**RESPONSES TO THE USEPA AND OEPA COMMENTS ON THE WORK
PLAN, GEOTECHNICAL SAMPLING AND TESTING AT THE SOLID WASTE
LANDFILL AND PROPOSED ON-SITE WASTE DISPOSAL CELL FOR OU 2**

**DOE-1118-94
DOE-FN EPA
11
OU2**

RESPONSES TO UNITED STATES ENVIRONMENTAL PROTECTION AGENCY AND OHIO ENVIRONMENTAL PROTECTION AGENCY COMMENTS ON THE WORK PLAN, GEOTECHNICAL SAMPLING AND TESTING AT THE SOLID WASTE LANDFILL AND PROPOSED ON-SITE WASTE DISPOSAL CELL FOR OPERABLE UNIT 2

FEMP SITE MAP

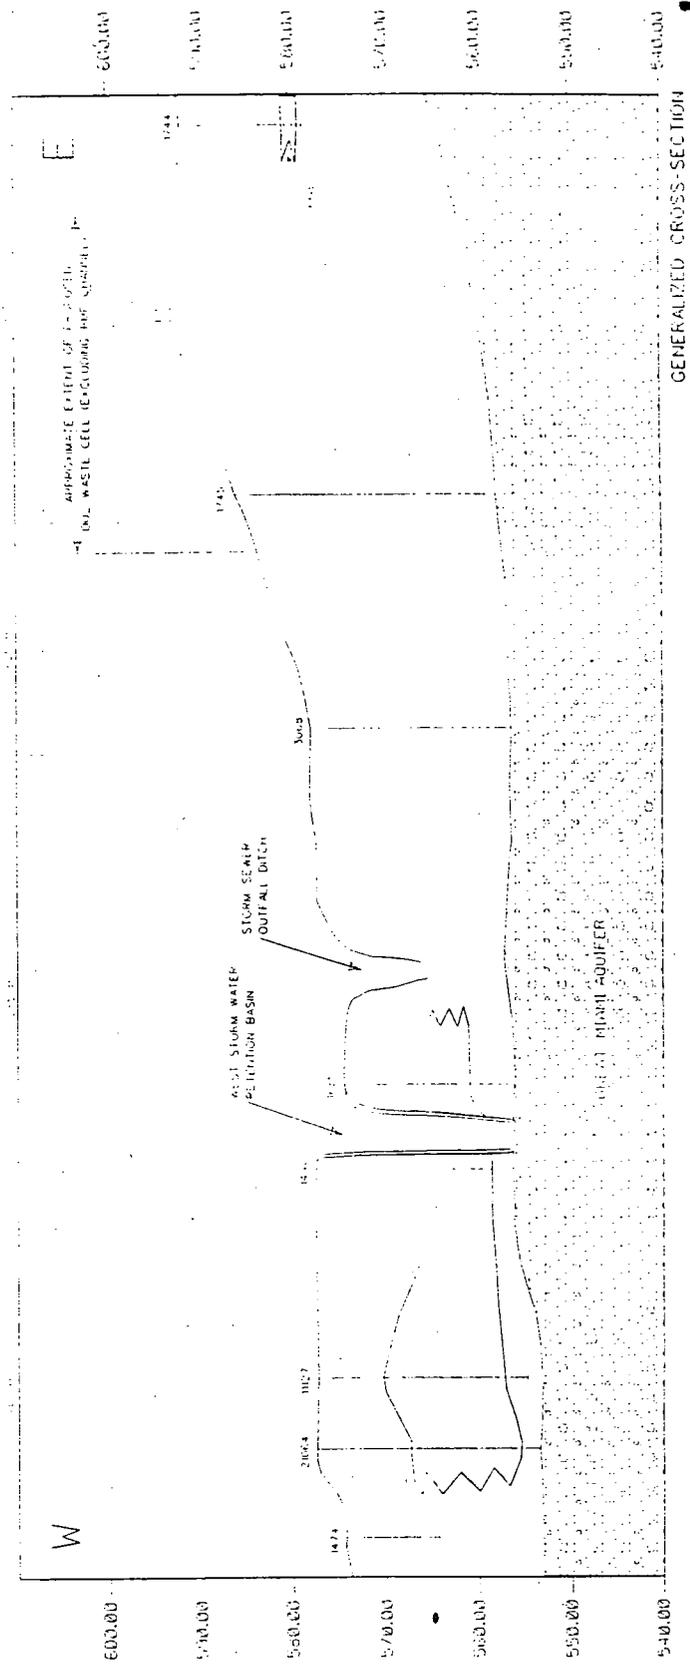
2. Commenting Organization: Ohio EPA Commentor: DDAGW
Comment: Task 2, Figure 1A. Thick sand deposits were encountered during the construction of the storm water retention basin. Where do these deposits terminate to the east, in relation to the proposed cell for OU-2 wastes?
Response: The lateral extent of the thick sand lens encountered in the stormwater retention basin terminates approximately 1200 feet west of the proposed disposal cell. The attached plan and cross-section show the extent of known sand deposits in the disposal cell area.
Action: No action required at this time.
